# SITE PLANS FOR SOUTH OAKS SITE CONDOMINIUM

CITY OF ROCHESTER HILLS, OAKLAND COUNTY, MICHIGAN

### Site Plan Review

Conditions and mark-ups noted throughout the plan set must be addressed prior to final approval.

DRAWN	MCS
DESIGNED	MCS
APPROVED	MCP
P.E. JOB No.	21-450
SCALE	1"=50'
<b>S1</b>	SITE PLAN

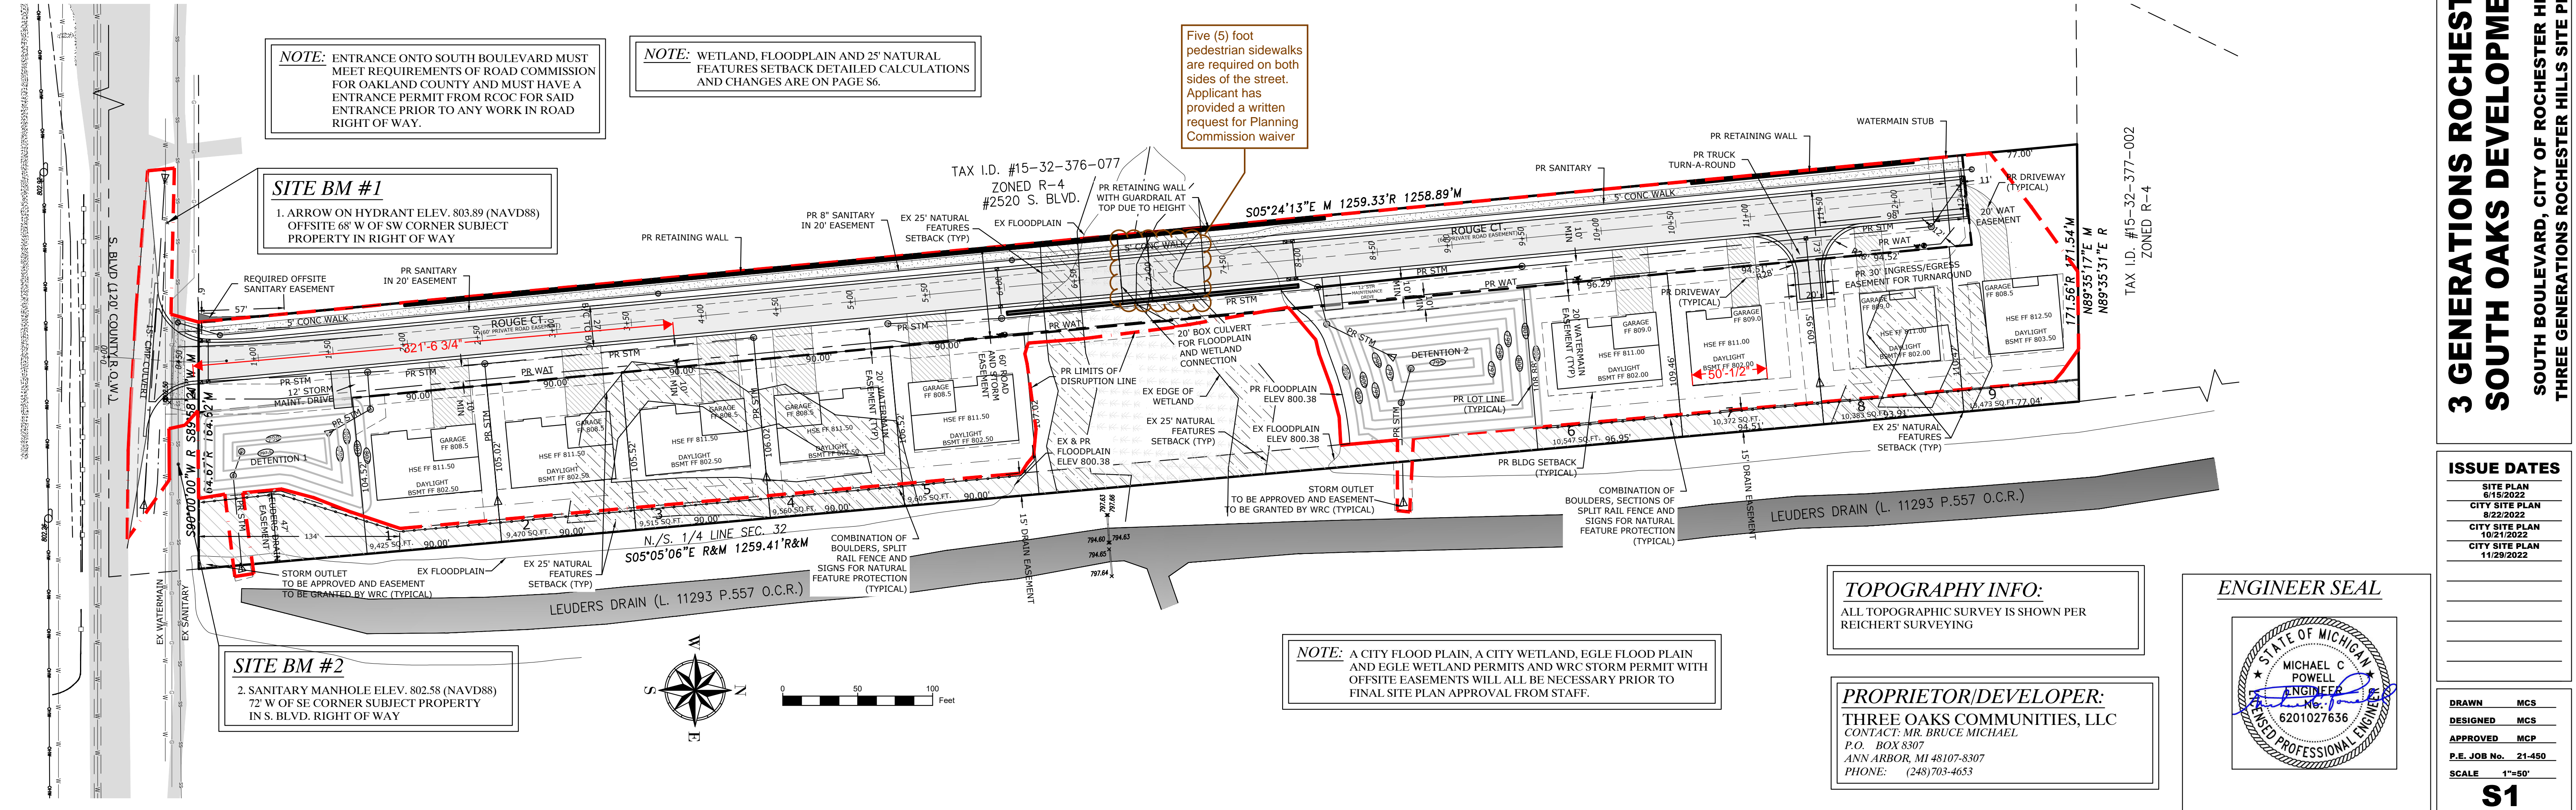
Provide a legend showing what the different hatchings are.

Five (5) foot pedestrian sidewalks are required on both sides of the street. Applicant has provided a written request for Planning Commission waiver

**DRAWN** MCS  
**DESIGNED** MCS  
**APPROVED** MCP  
**P.E. JOB NO.** 21-450  
**SCALE** 1"=30'  
**S2**  
**SITE PLAN**

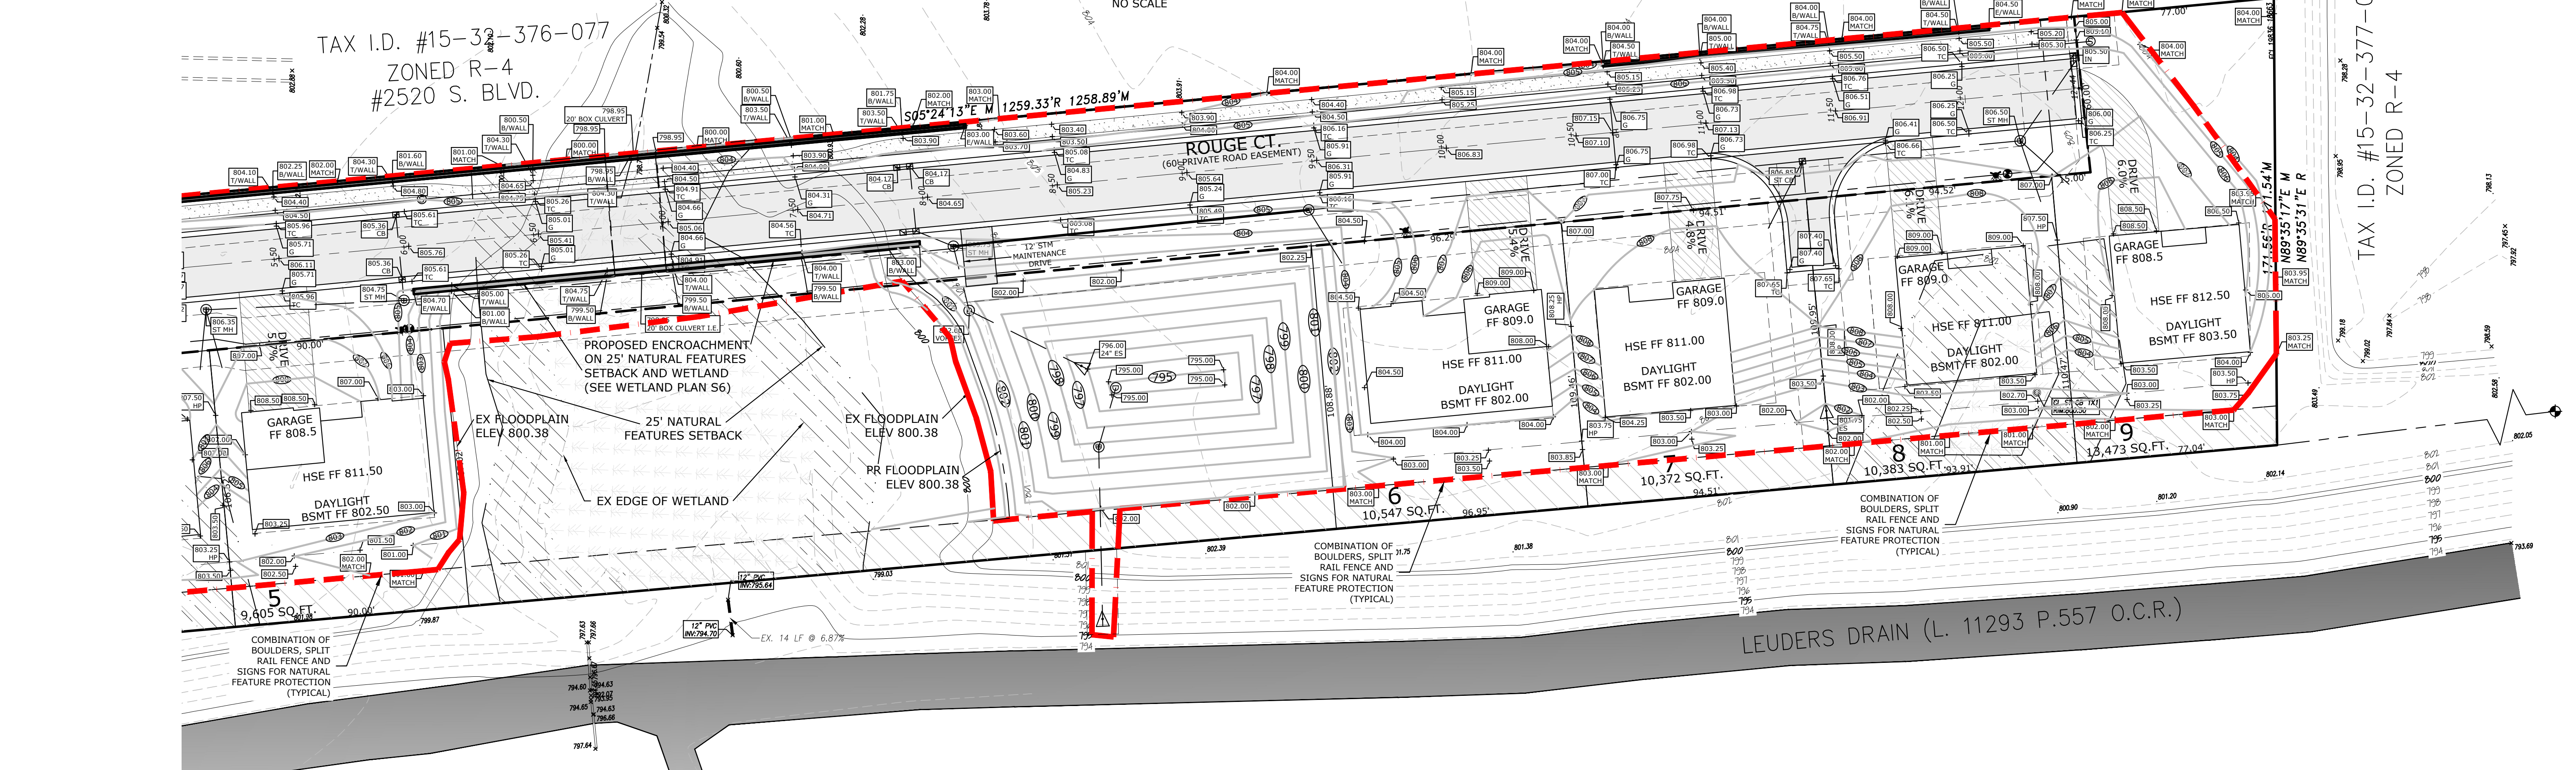
Clearly show that the grades within the street intersection do not exceed 3.0% for a distance of 100 feet from the point of intersection.

**L-3**

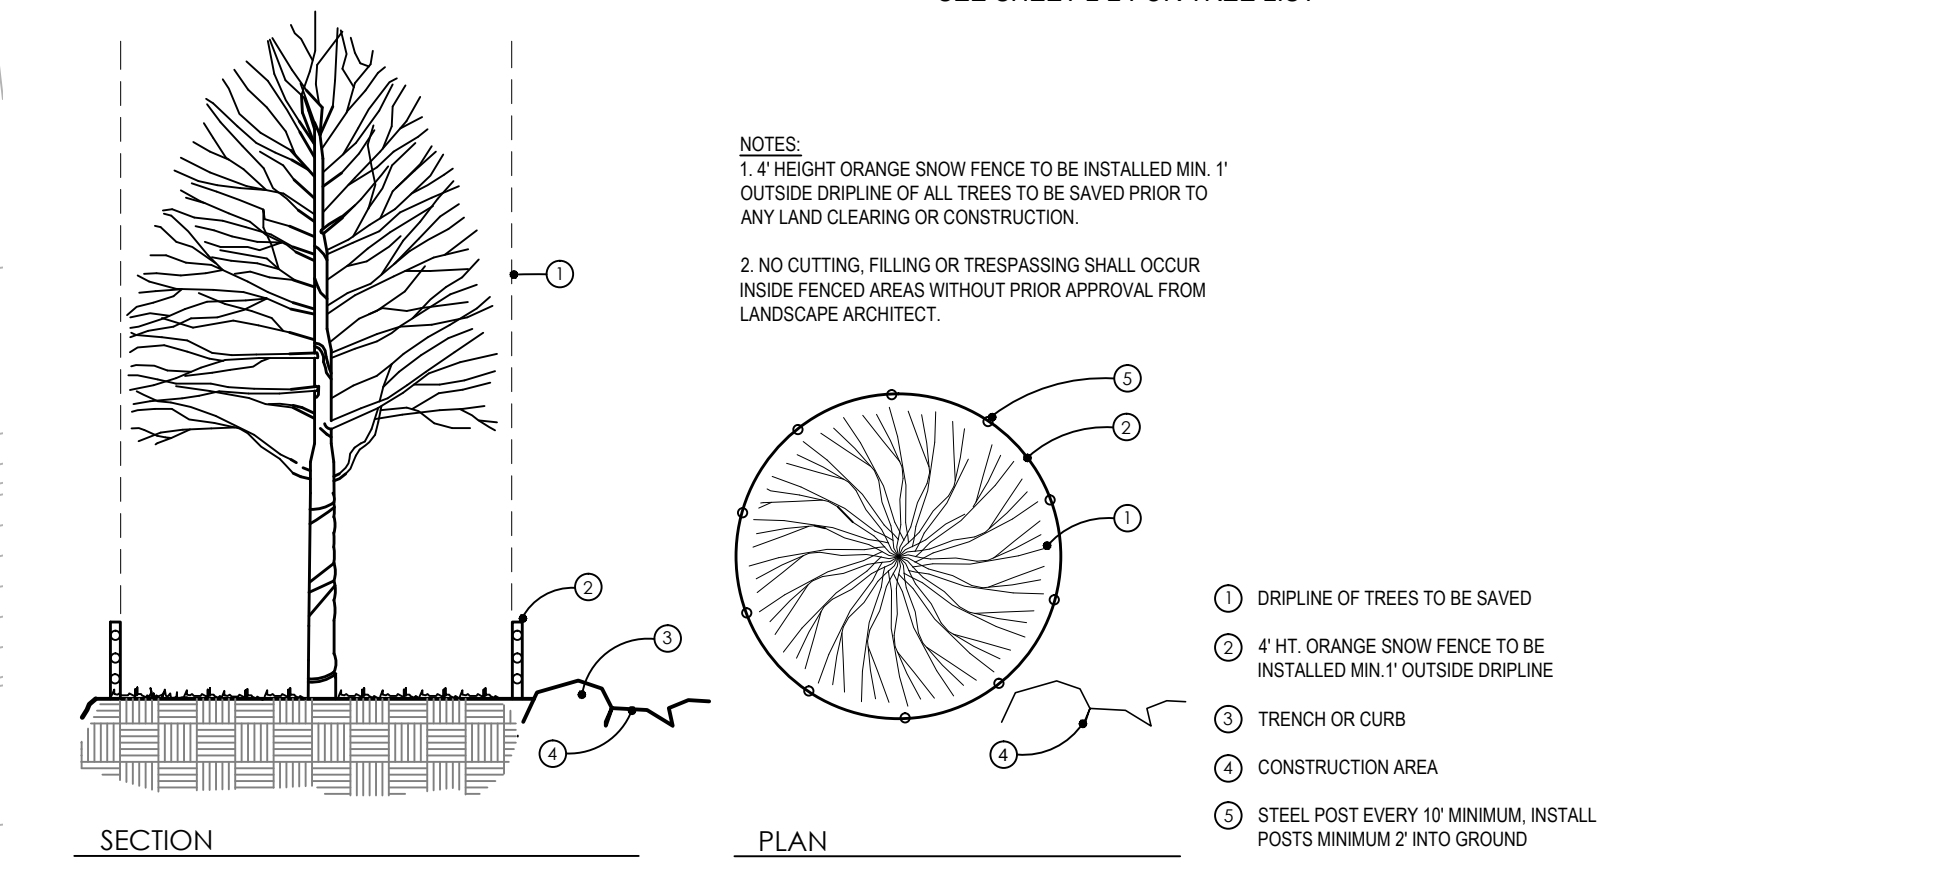
Provide four (4) shrubs per 100 linear feet of basin perimeter
